Technical Advisory Committee

Meeting Minutes

January 5, 2023

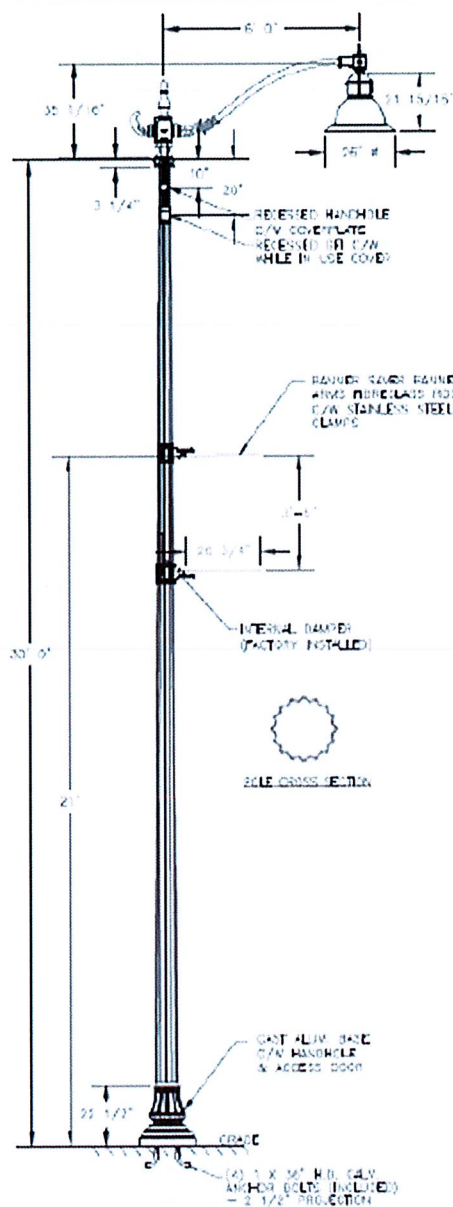
13. Streetlights are required by the PUD:
 - a. Civic Drive
 - i. 1 light every 75' on both sides the street
 - ii. Median shall feature a streetlight at both ends
 - iii. These lights shall match that used by Phase I of McCord Square. Kimley Horn should have the spec.
 - b. Broadway – as required by the Zoning Ordinance. Spec enclosed.
14. We have had extensive discussions regarding design and maintenance of dry detention. It was previously stated that under-drains and other elements could be added to ensure an aesthetically pleasing appearance. We don't see any such elements.
15. Please provide a landscape plan for the median and common areas, meeting the requirements of the PUD.
